# UNITED STATES PATENT AND TRADEMARK OFFICE

APPLICATION NO.	FILING DATE	FIRST NAMED INVENTOR	ATTORNEY DOCKET NO.	CONFIRMATION NO.
09/647,700	10/03/2000	Birgitte Hansen	36636-166652	1109

# Office Action Summary

FIG. 7

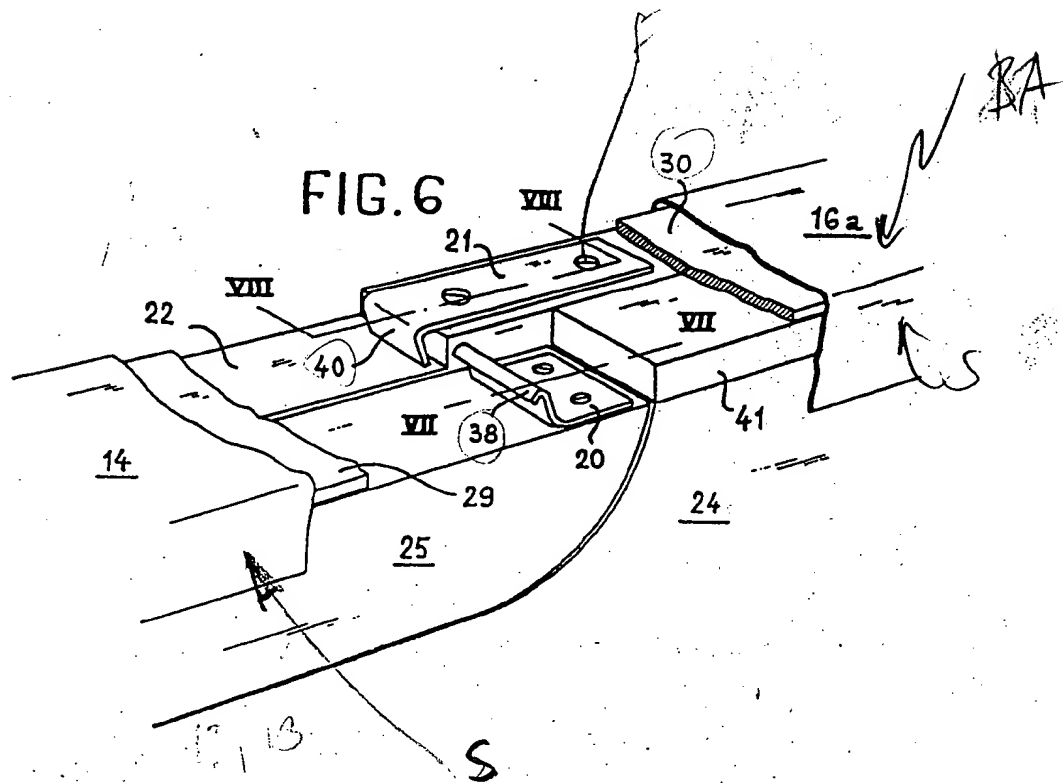
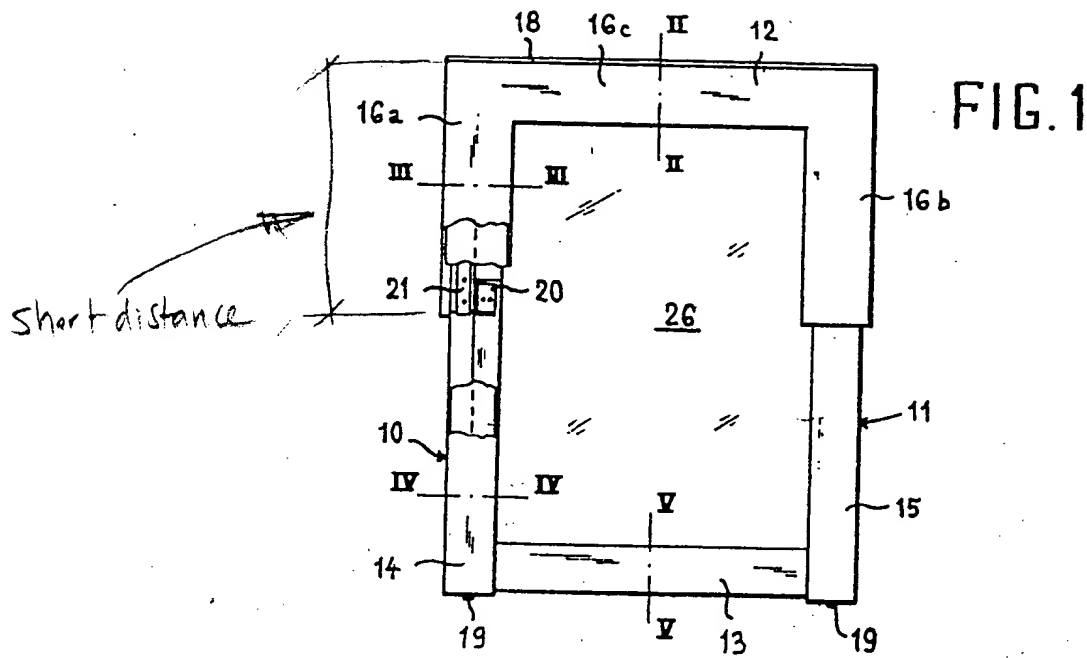
Regarding claim 2, as shown in figures 1 and 7, the main frame is a pivot sash wherein the upper covering (16c) covers the upper frame member (23,24) and the exterior cover (13) and the cap members (14,15) covers the side members (25) of the frame. In reference to claim 3, the window has a pivot axis (PA) halfway between the top and bottom members (23,24) and the cap structure has an upper cap (16a,b) a short distance from the upper end of a lower cap member (14,15) and the lower cap member (14,15) placed on either side of the pivot axis (PA) and provided with securing means (34,36,SM) secured to fittings (19,28,42), see figure 3, on the side frame members (25).

FIG. 8

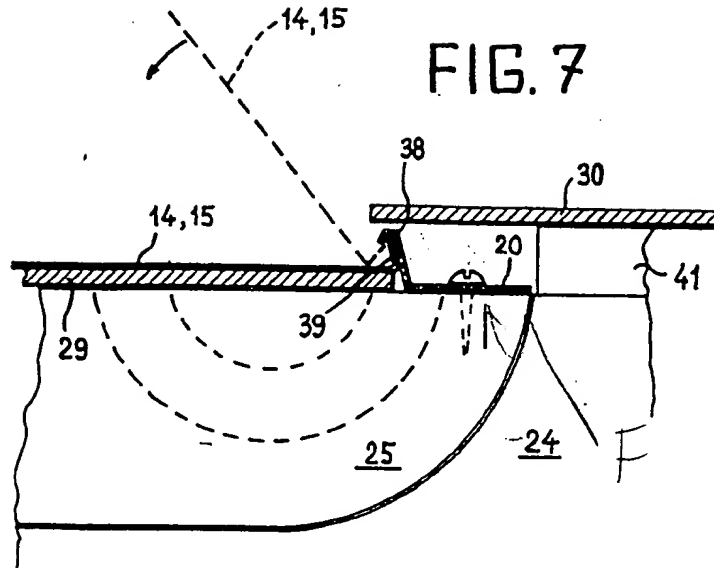
and side (25) members. The covering members (12-15) include an upper covering cap (16c), and interior glazing profile (30,41), an exterior covering member (13), and a cap (16a,b), (14), (15) that extends between the top and bottom (23,24) members and overlapping the glazing profiles (30,41), see figure 8, and the covering member (13), see figure 1 where (14) and (15) covers (13). The cap structure has a top end (16a,b) and a bottom end, as at (14) and (15) wherein the top end (16a,b) is dismountably retained solely by the upper covering (16c) because the top end (16a,b) is integral with the upper covering (16c). The cap structure is formed with at the bottom end with a bent hidden engaging means (B) that snap engages with an engagement means (EM, 40) secured at the lower end thereof, see the marked attachment. SE374578 discloses the basic claimed window except for, without a translation, explicitly detailing that the frame members are made form wood. From the drawings, it would have been obvious to one having ordinary skill in the art that the hatch lines used to represent the frame members of SE374578 are representative of members made from wood.

Regarding claim 4, the engagement means (EM,21,40) includes an engagement bracket (21) parallel to the cap member (16a,14), see figure 8, wherein the bracket (21) has a hole (note labeled) for receipt of a pin fastener (F) in to the side member (25). SE374578 does not teach a keyhole; however, keyhole apertures are old and very well known in the art. Hence, it would have been obvious to one having ordinary skill in the art to provide the assembly of SE374578 with a keyhole aperture in order to provide the window assembly the ability of the cover to be adjusted for mounting purposes. In reference to claim 5, the securing means includes holes (unlabeled), and the fittings (19,F) are screws. Regarding claim 6, screw fittings (19,F) are connected with a swing fitting (20,21) with the main frame. In reference to claim 7, the cap structure includes at least one cap member (16a-c,14,15) which are flat U-shaped members that covers the glazing profile (30,41) and the exterior cover (13). Regarding claim 10, the lower cap (13) has a bottom wall (BA) and two side walls (S), see the marked attachment. In reference to claim 14, the covering members (12-15) are secured by screws (19,F). SE374578 discloses the basic claimed structure except for the use of a plastic bushing. Although bearing bushings are not disclosed; however, bearing members are old and well known in the art to use bearing bushings with fasteners in order to aid in the members having a firm a connection therebetween.
